**DAVID PLUMMER & ASSOCIATES**

June 3, 2015

**Re: Mediterranean Village Review - #14153**  
**Traffic Impact Study, Parking Analysis & Valet Operations Analysis**

HOTEL DROP-OFF - OPTION #1 “ORIGINAL SUBMISSION”

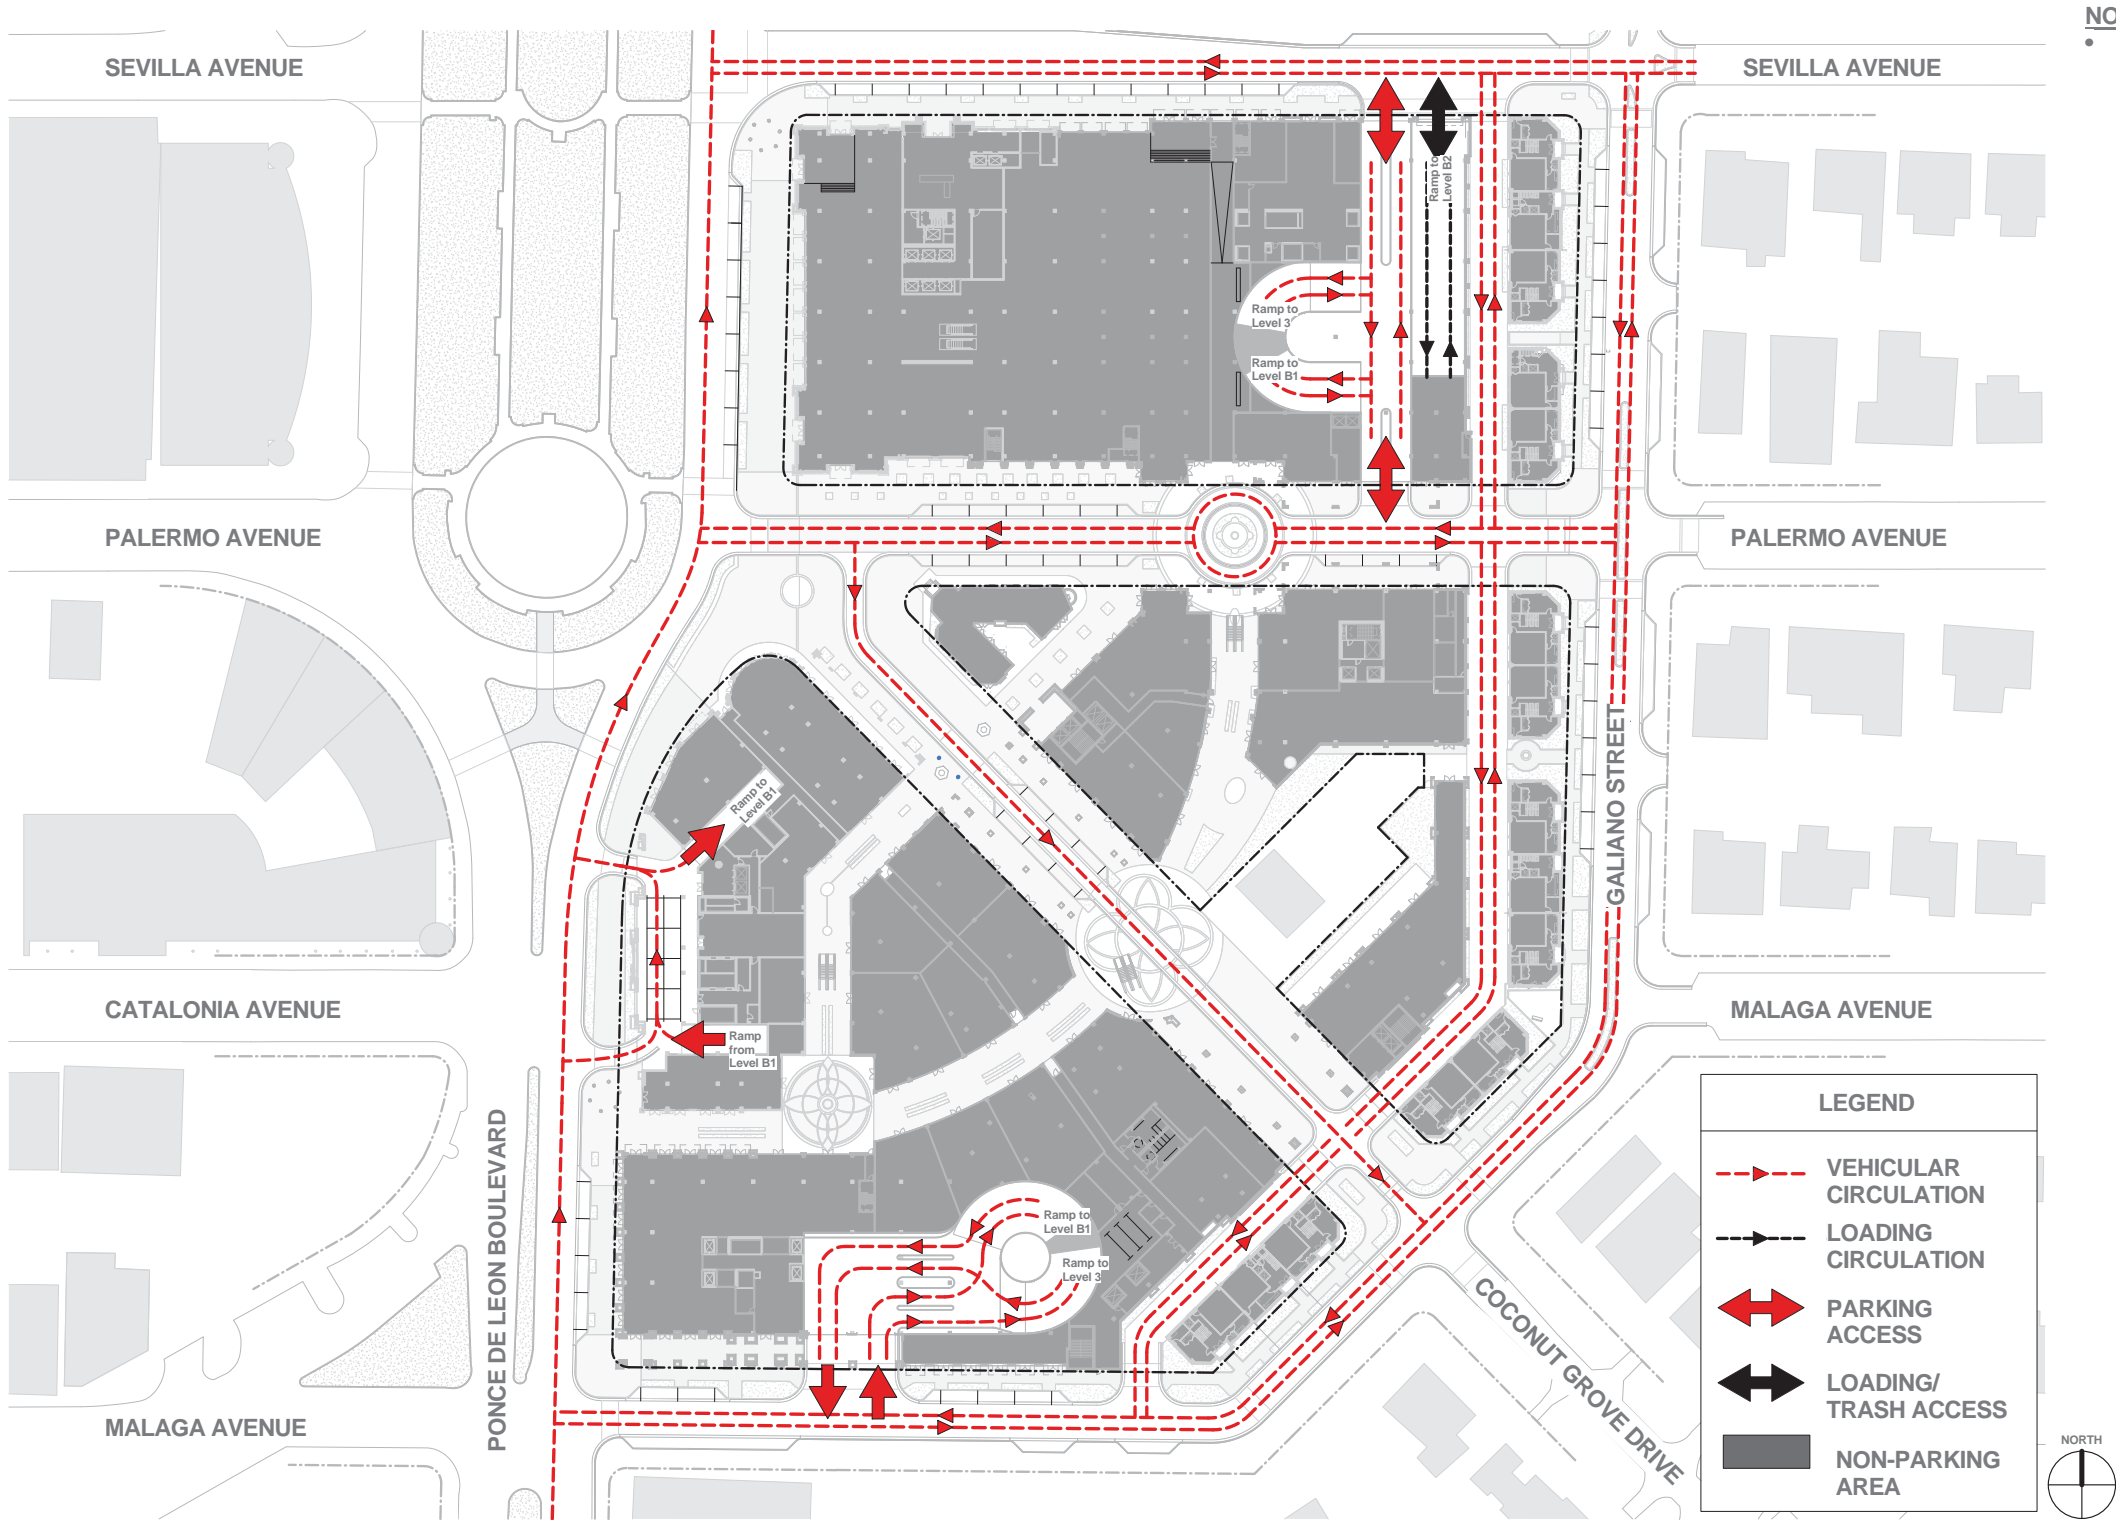
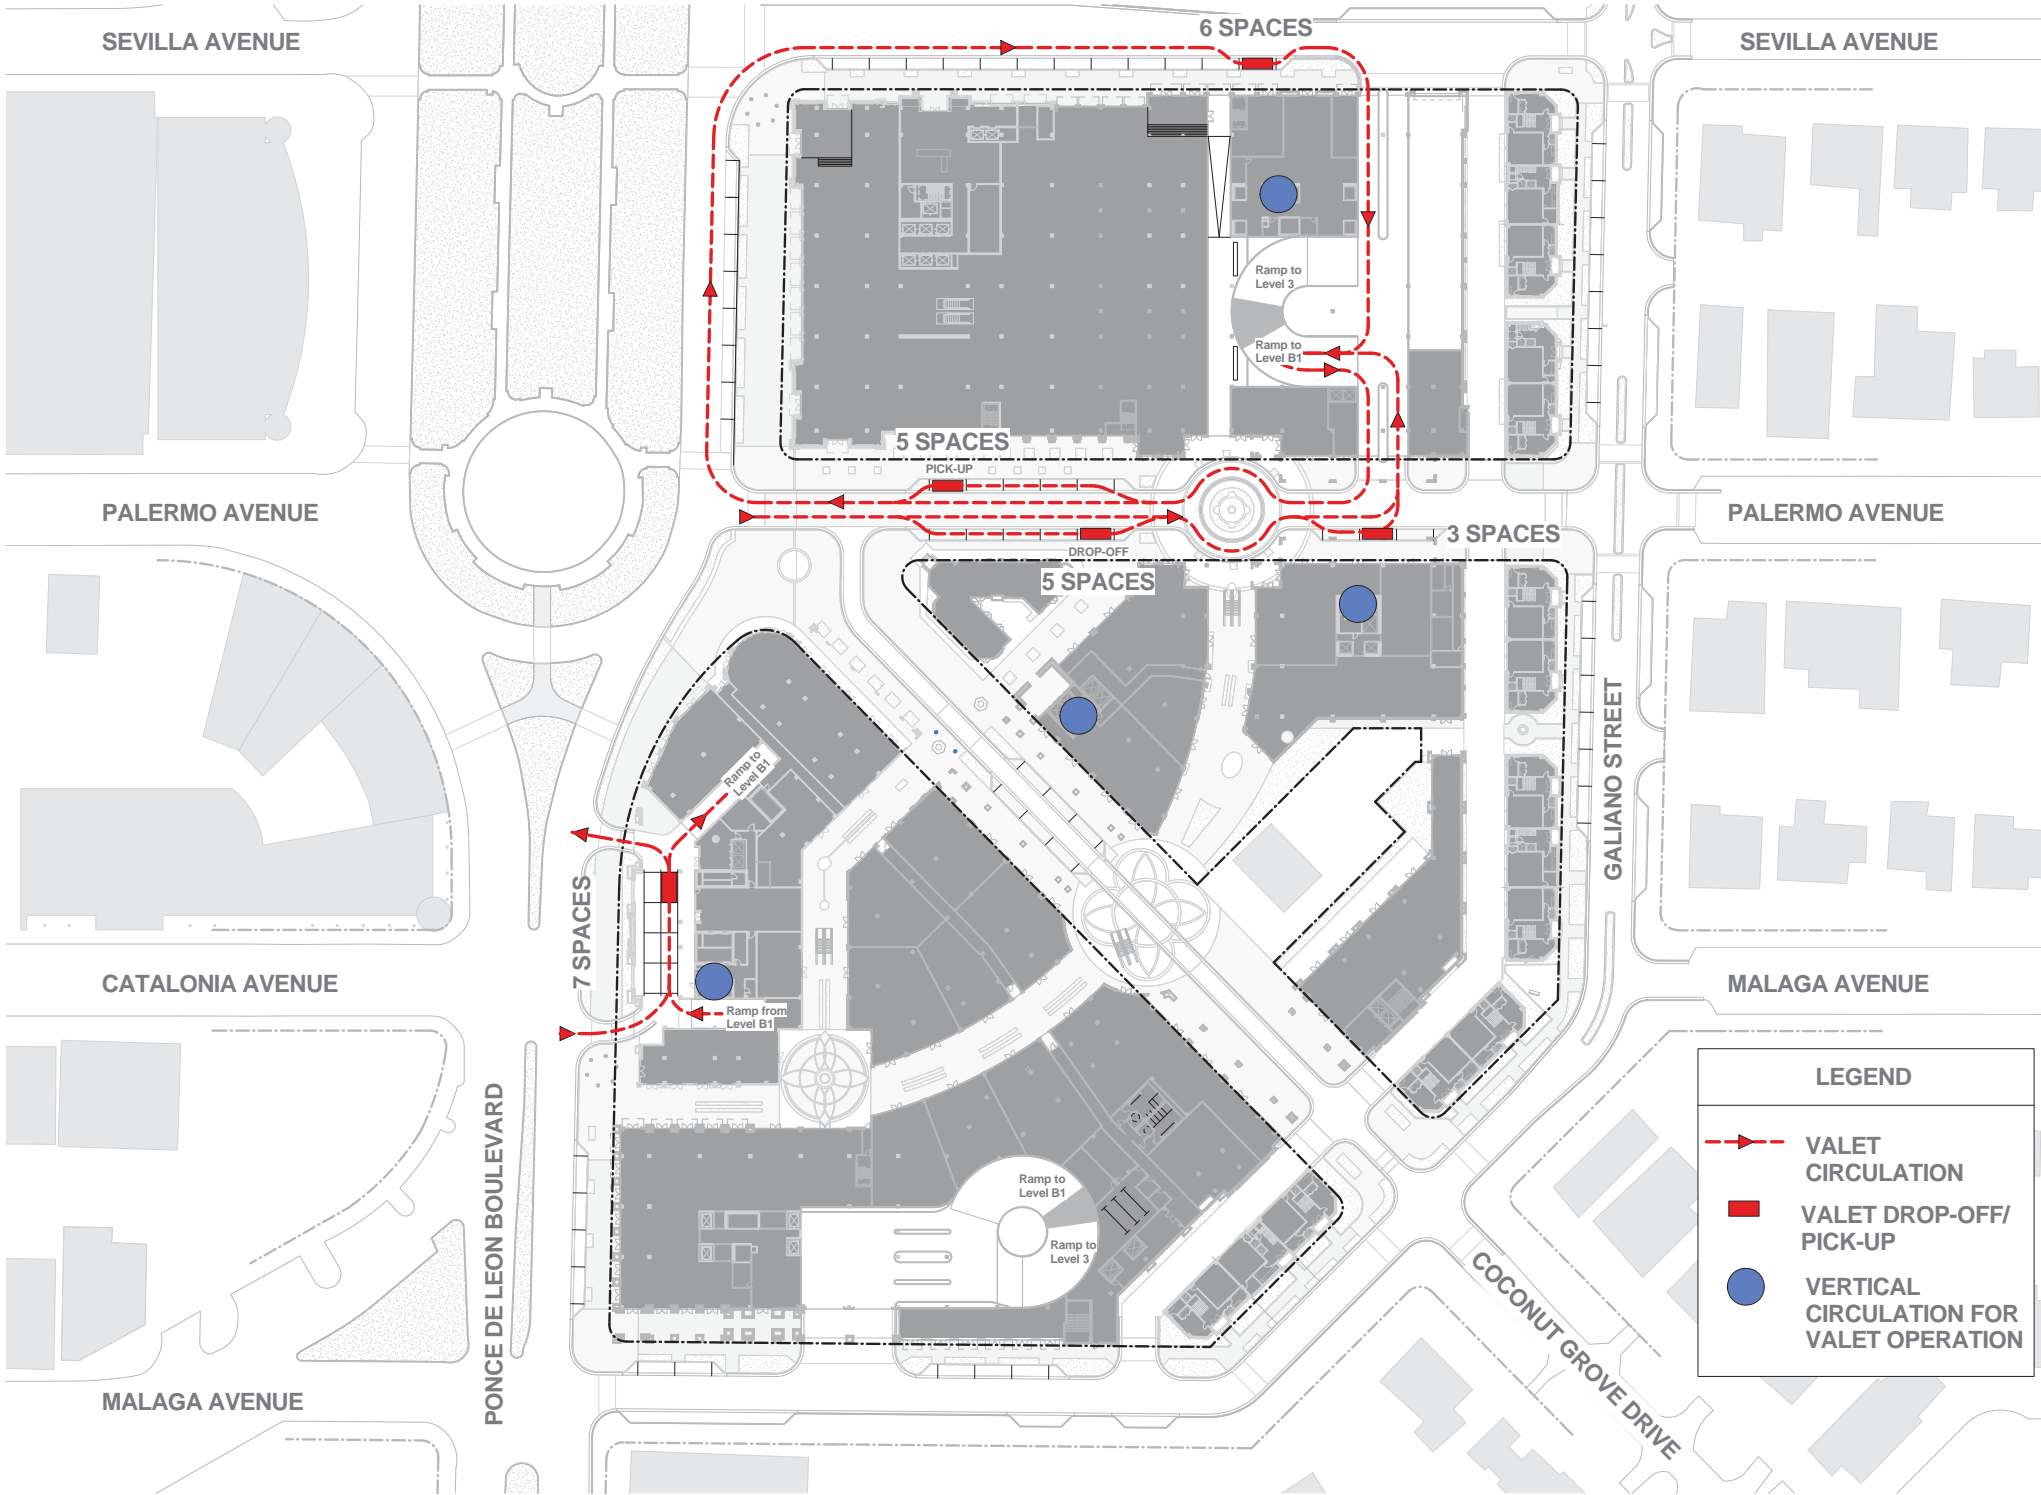
During first reading, the project included direct access to the hotel from Ponce. This access plan for the hotel was acceptable. The project has since changed to address comments from the Commission. Of the newly proposed options, Option 3 is an acceptable alternative and preferable to Option 2 provided that the following conditions are included: 1) the hotel valet ramps will be completely segregated from the Malaga driveway ramping system and no traffic from Malaga would be allowed to access the hotel's porte cochere, and 2) two one-way ramps (similar to the Ponce alternative) or a two-way, two-lane ramp for hotel valet use only is provided. See attachments for hotel access options.
